FRAMING PLAN - 1ST FLOOR - 12/18/2018
ORGANIC GROCERY STORE

FRAMING PLAN - ROOF - 12/18/2018
ORGANIC GROCERY STORE

① RCP - FRAMING - 2ND FLOOR
1/4" = 1'-0"

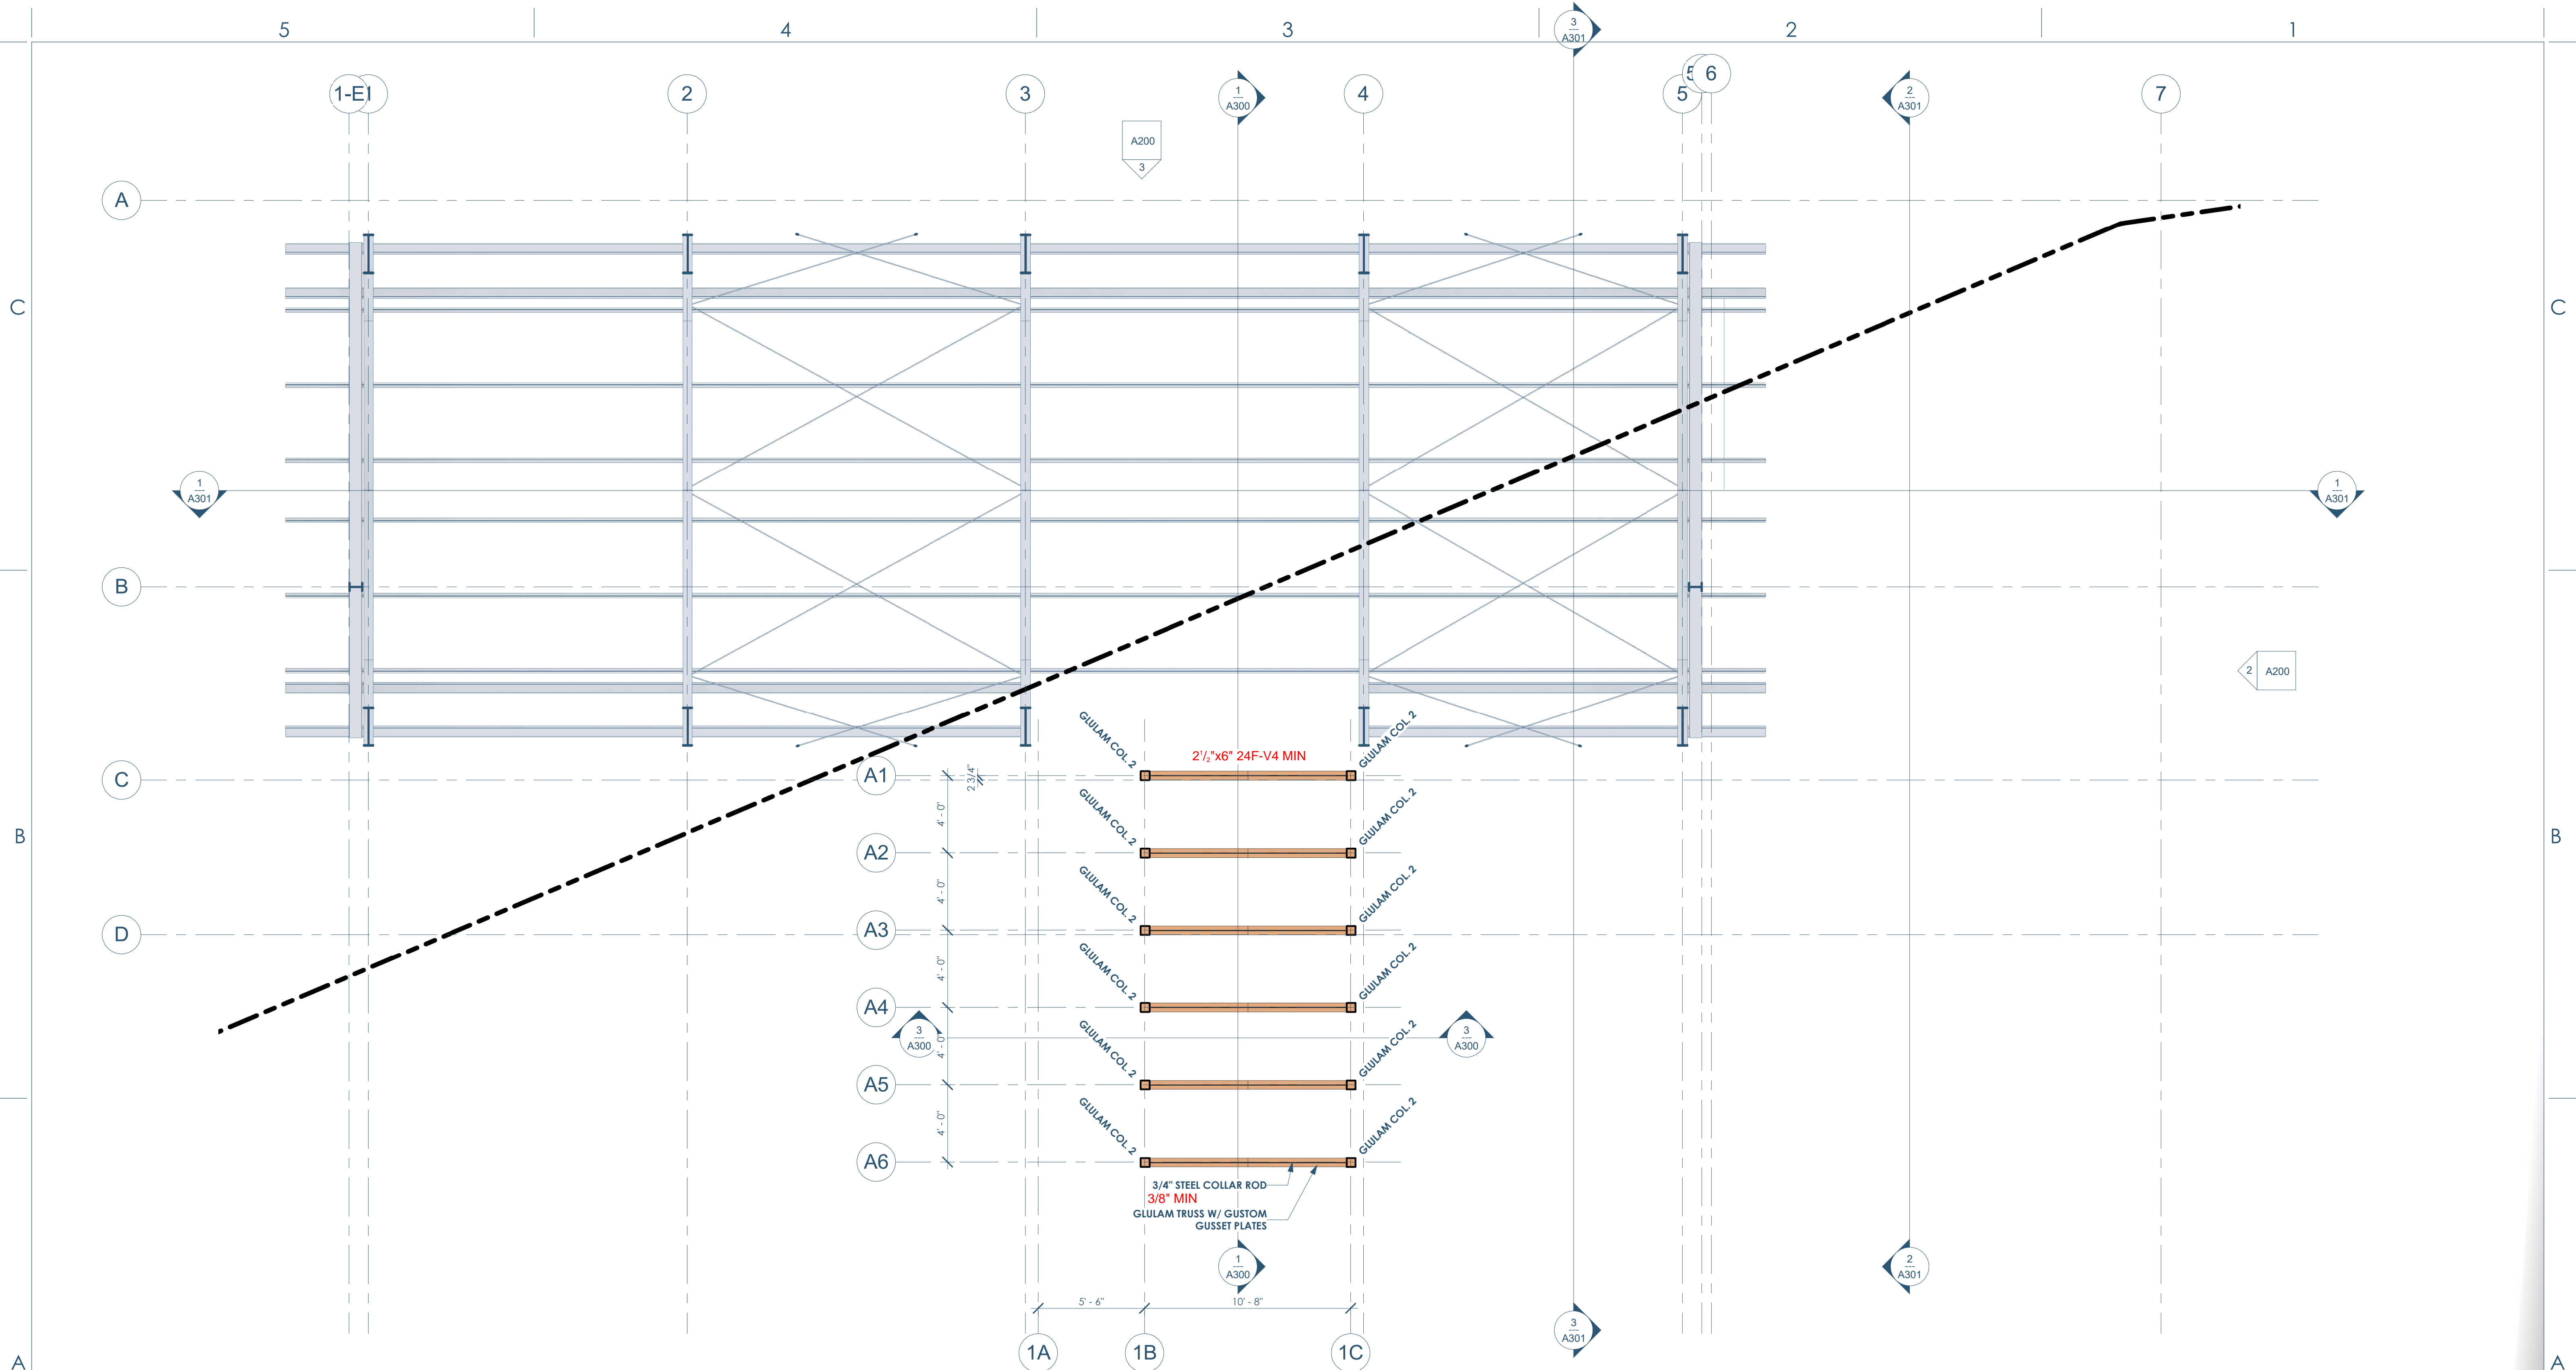
HOW DO WE WANT TO SUPPORT THIS? CAN WE DROP THE CANTILEVERED OUTRIGGER AND ATTACH TO THE LVL BEHIND?
